RFT 21-134 Renovations – Burlington Central HS

The following, issued by the Halton District School Board May 11, 2021, shall be incorporated in the specifications and shall form part of the proposal document for the above.

- Architectural Addendum #2 dated May 6, 2021 provided Snyder Architects Inc. - 4 pages and attachments as noted.
- REVISED Form of Tender.

PAGE 2 OF 93
END OF ADDENDUM 3

2	EXISTING SPECIAL ED ROOM
A201-D	N/A

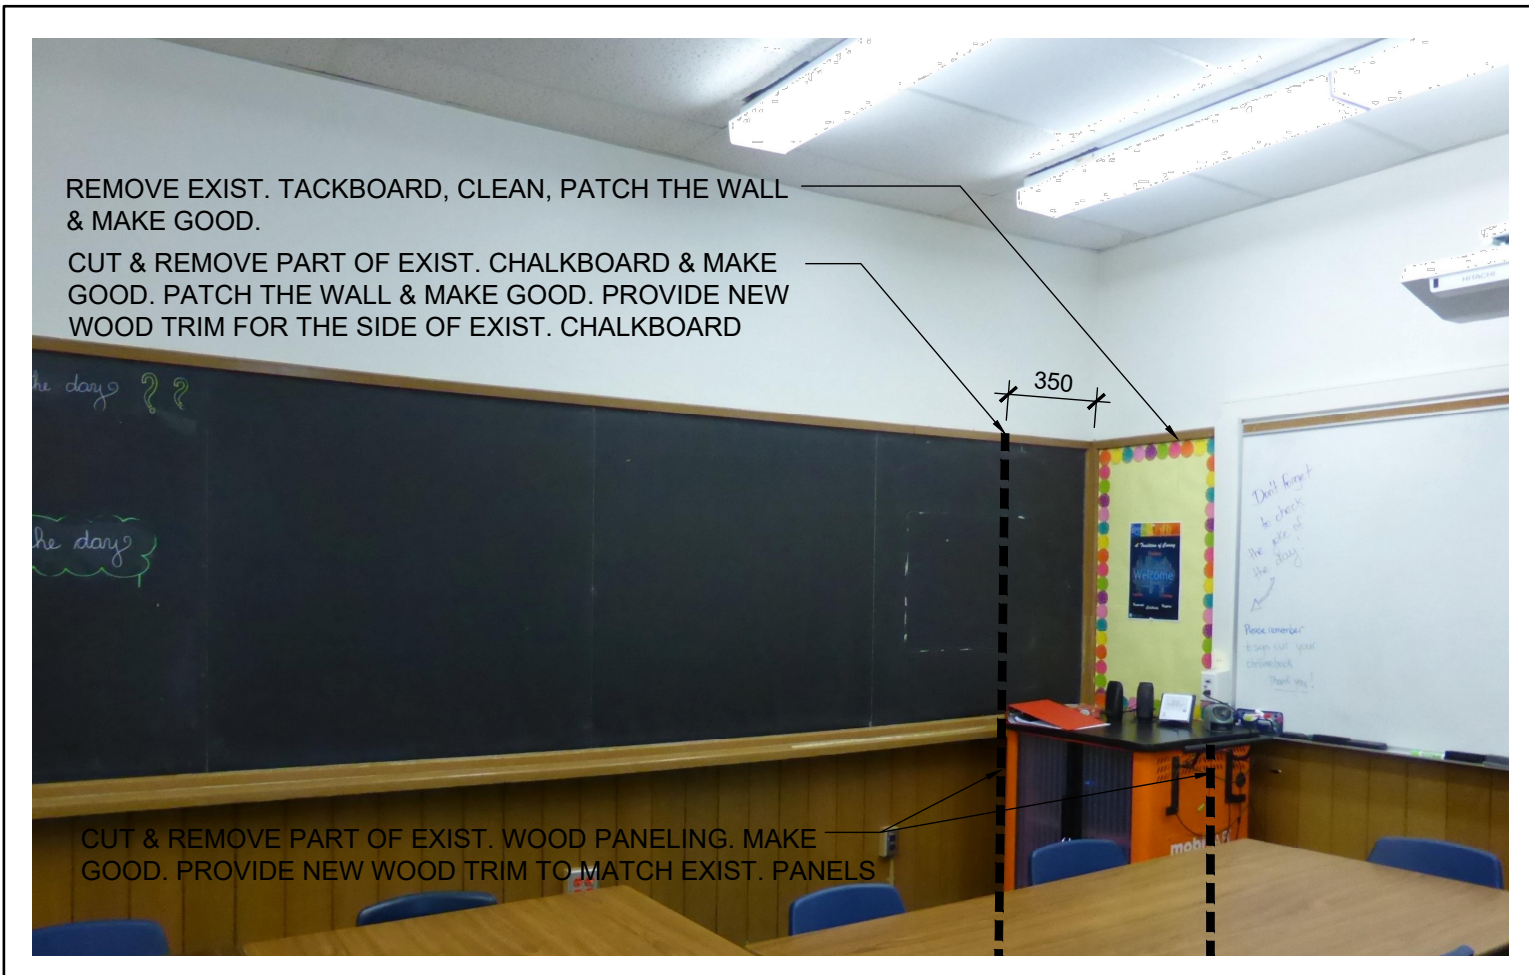
3.d	<p>Drawing 1/A201</p> <ul style="list-style-type: none"> - New notes added
3.e	<p>Drawing A201-D</p> <ul style="list-style-type: none"> - detail 2/A201-D added

7 LINTEL SECTION DETAIL AT GEN. OFFICE (RM101) DOOR
A500 1:10

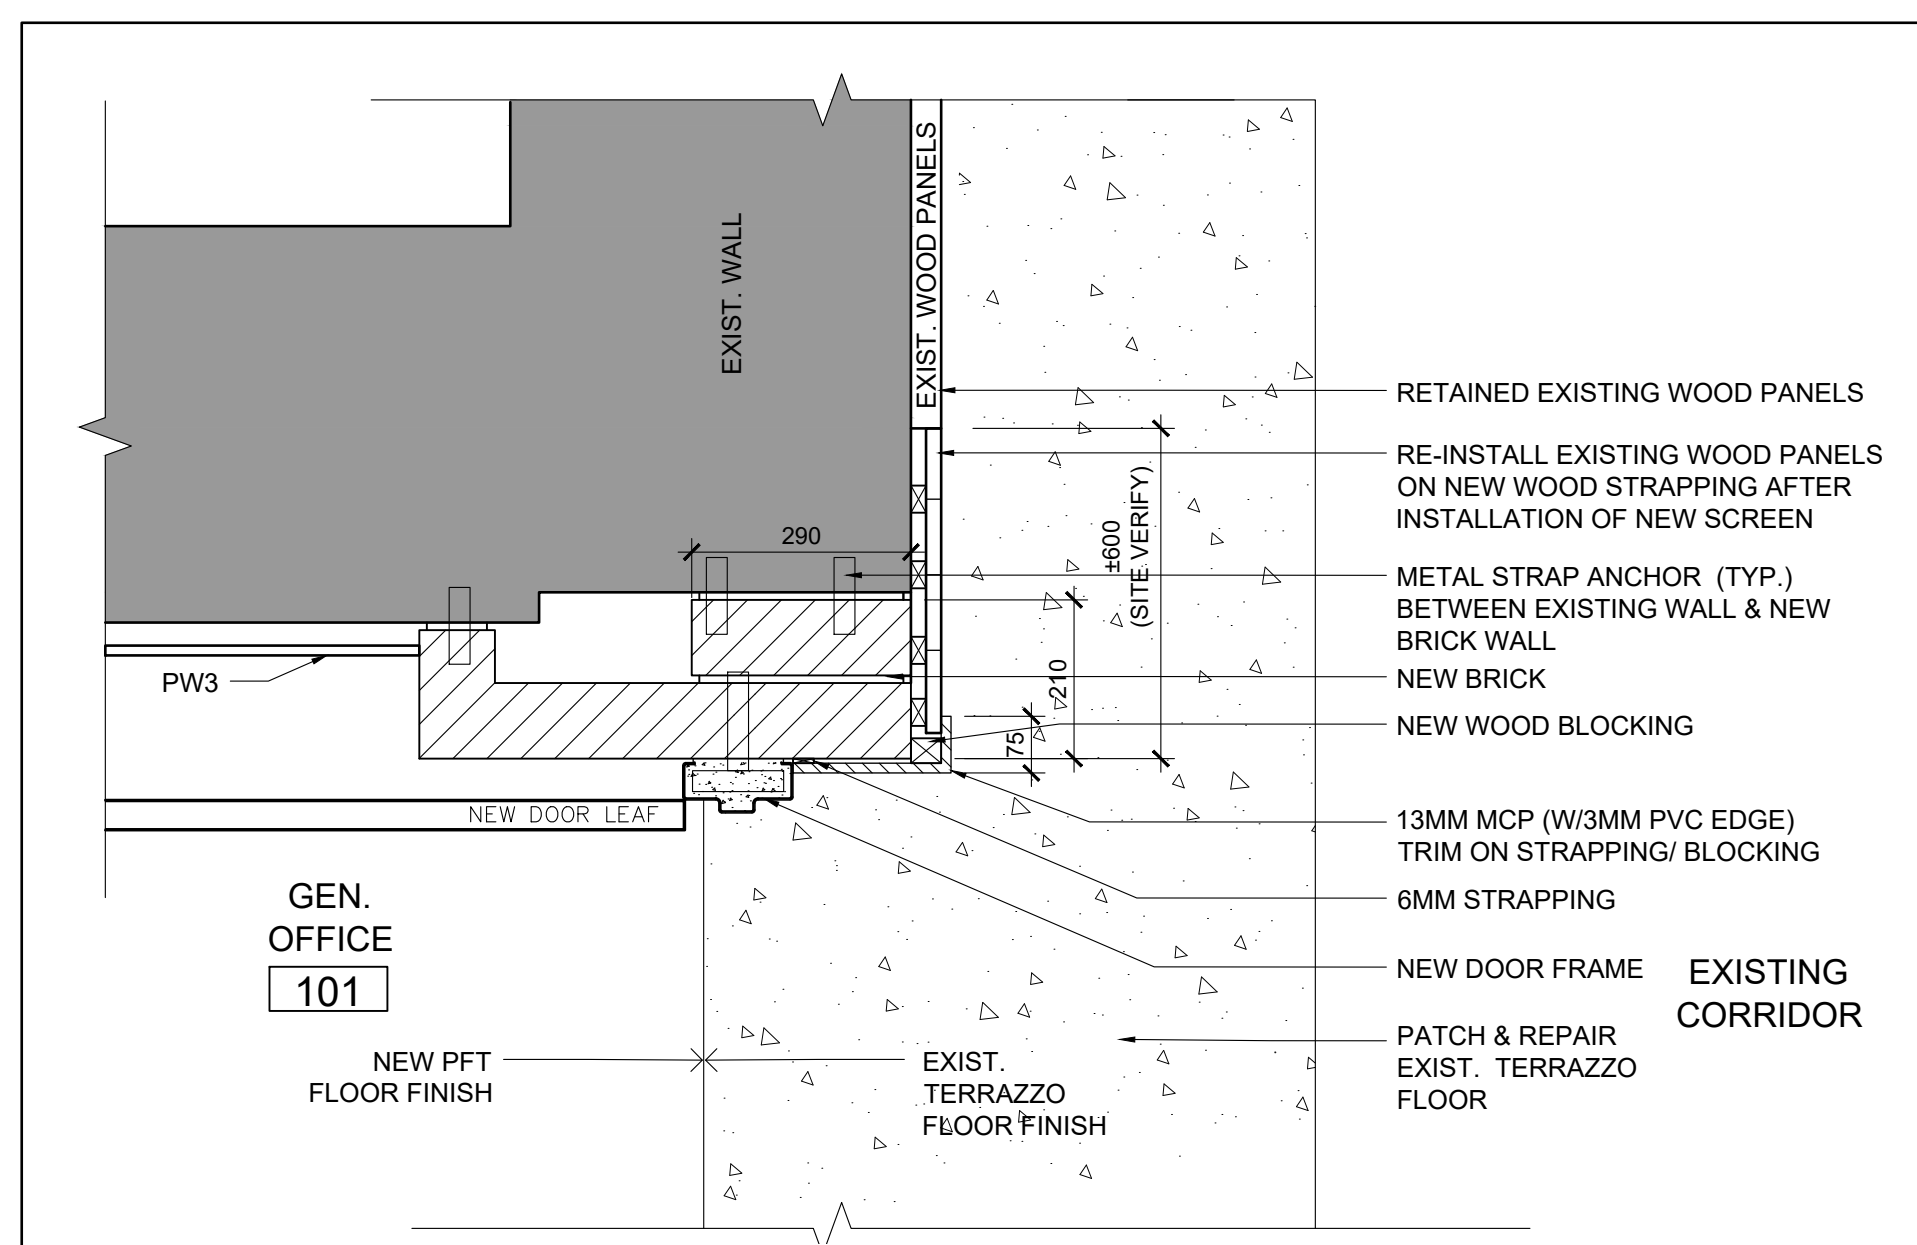
3/A300: - Notes added
3.i	Drawing A500 - New details 5/A500, 6/A500, 7/A500 added 2/A500: - Notes added - Extent of new terrazzo finish added
3.j	Drawing A501 - New note added 1/A501: - Drawing details revised and updated 2/A501: - Reference numbers revised

3 DOOR, FRAME & SCREEN TYPES
A800 1:50

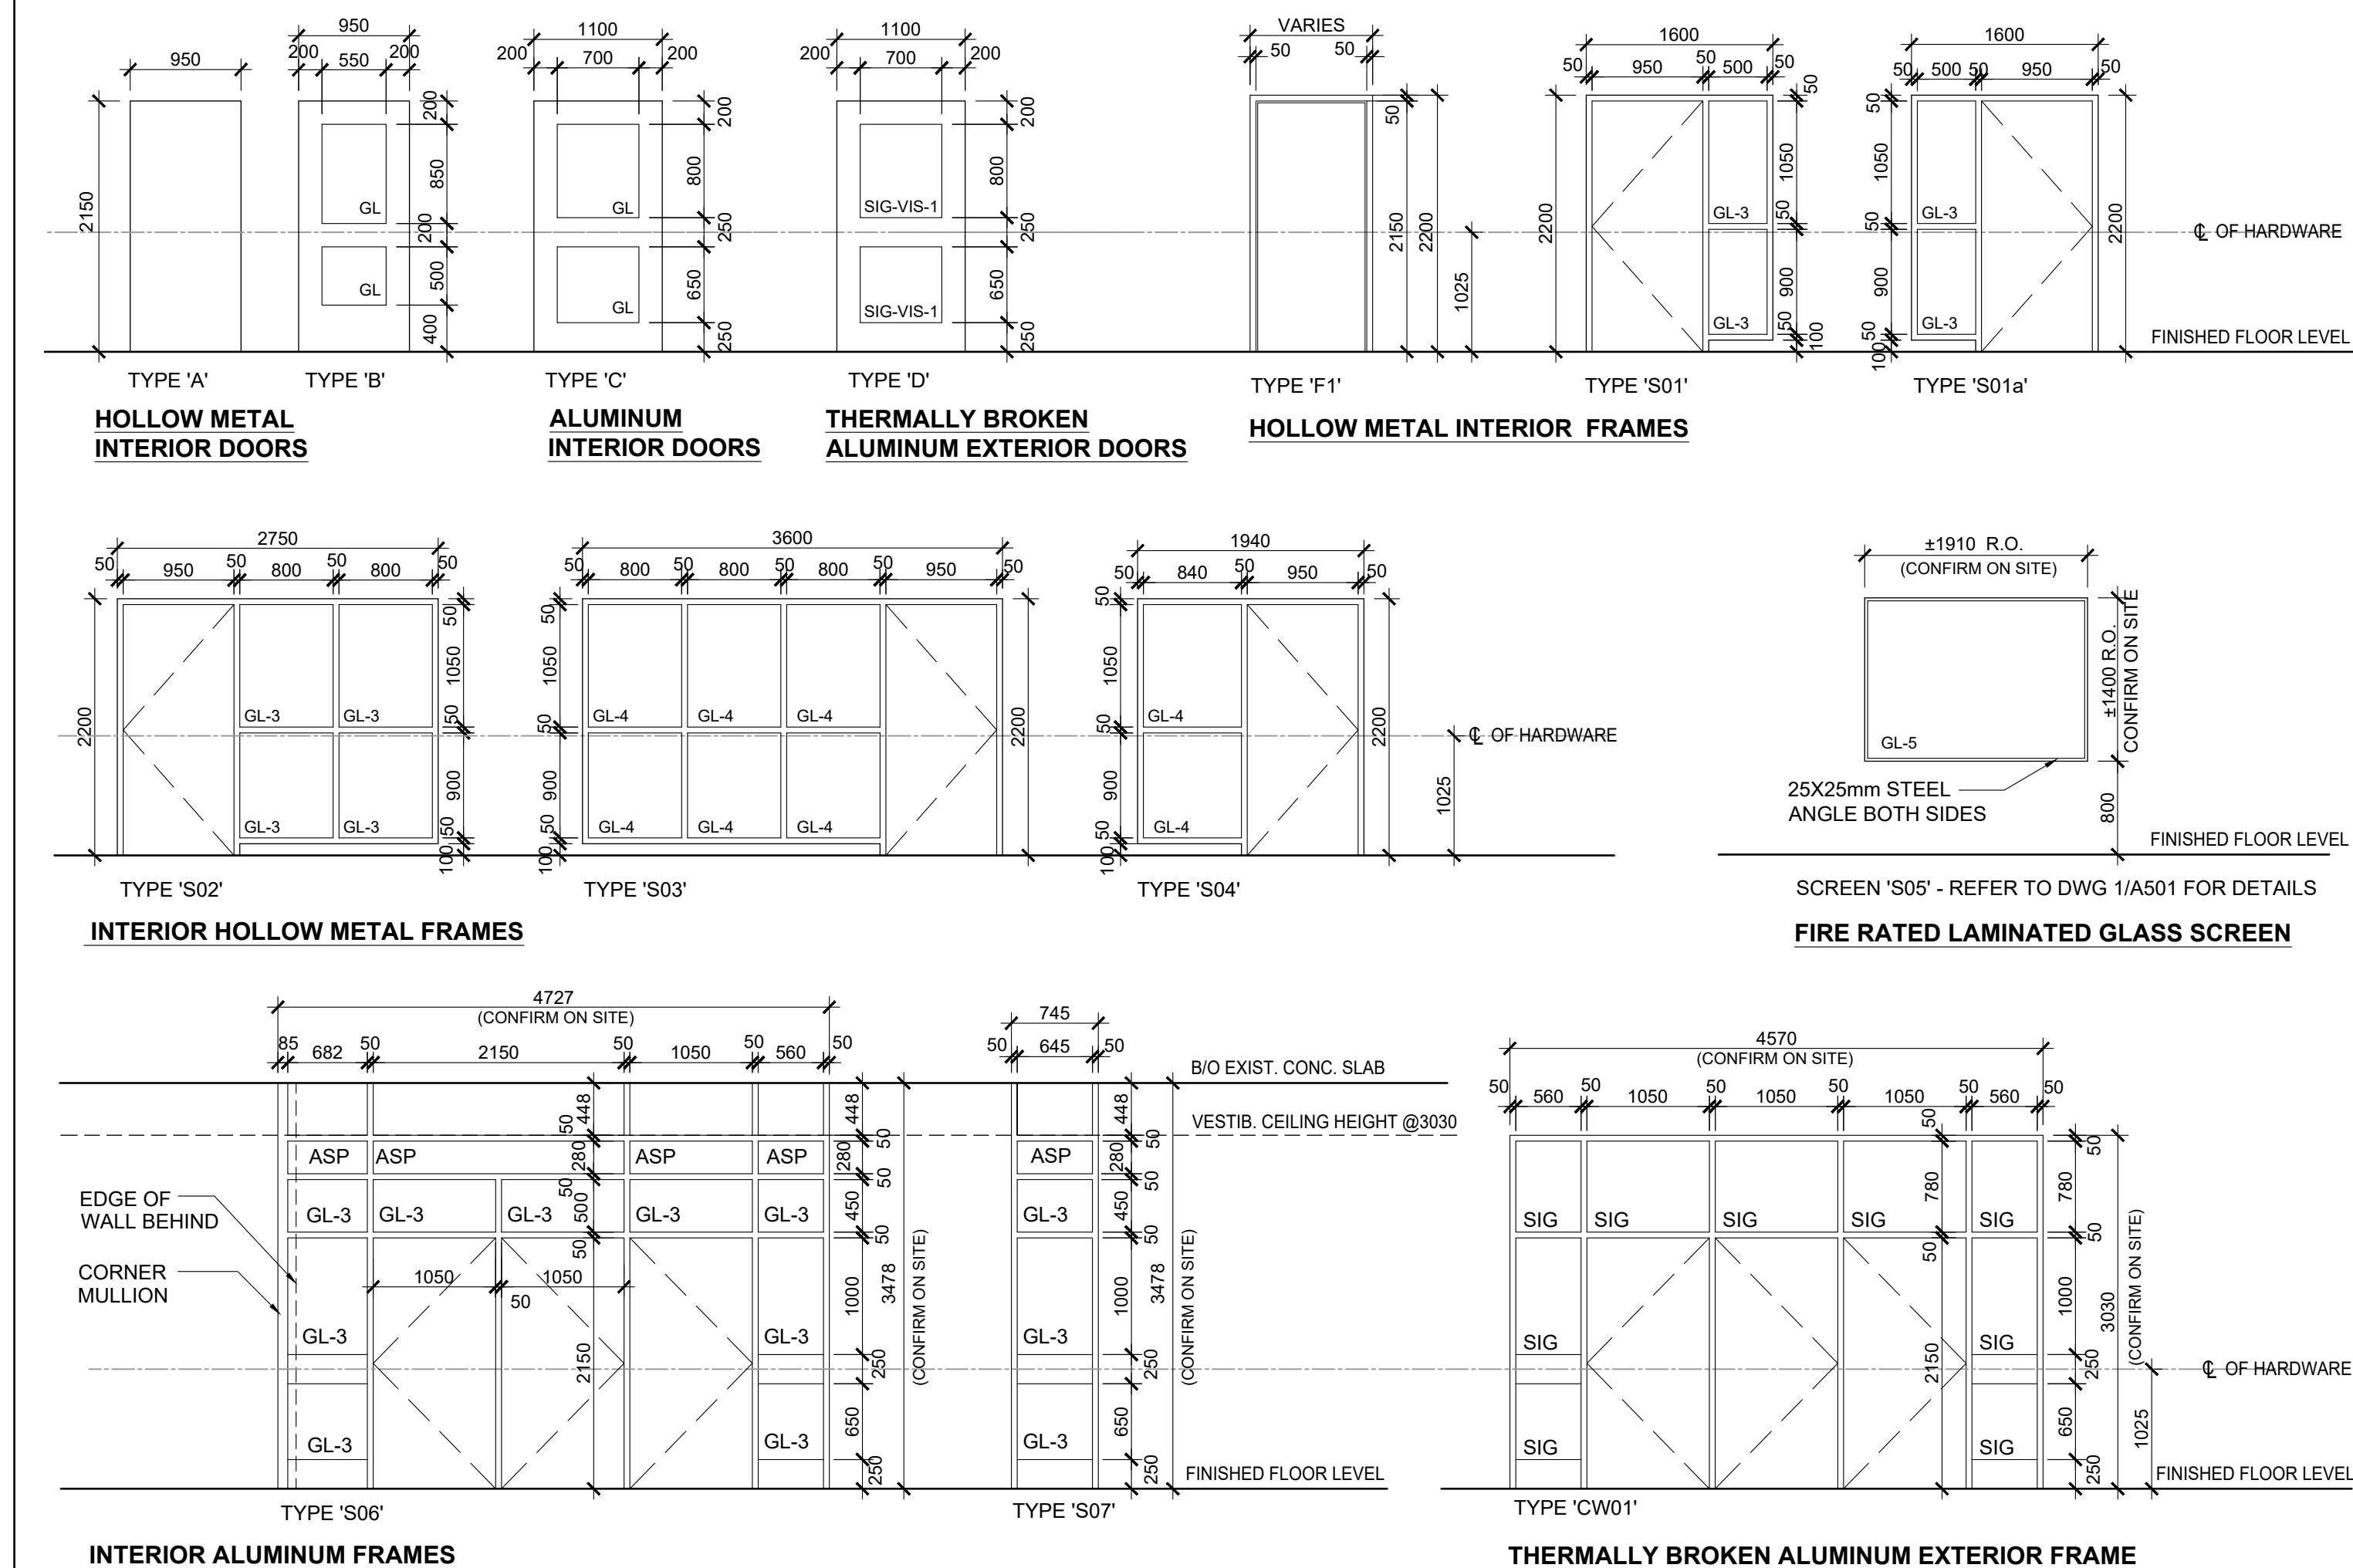
Going through the drawing & specs, we see the door schedule says WD - Type B but there are no specs for wood doors and the drawing for Type B door is labeled Hollow Metal, see 3/A800. Please confirm the material for new interior doors 101-118.

3.n	Drawing A701 - New elevation 9/A701 added 3/A701: - Elevations of print/copy room 108 revised 7/A701: - Elevation 1 revised
3.o	Drawing A800 - Door Schedule: Door & frame 116 revised - Door Schedule: Door 118 to Univ WR revised from WD to HM - Room Finish Schedule: Univ WR -118 floor finish revised; Legend – PCT revised to PFT-1 - 'ASP' shown on interior aluminum frame Type S06 (ref dwg 3/A800) to be similar to Insulated Metal Infill Panel described in section 08 51 13, 2.6.3.
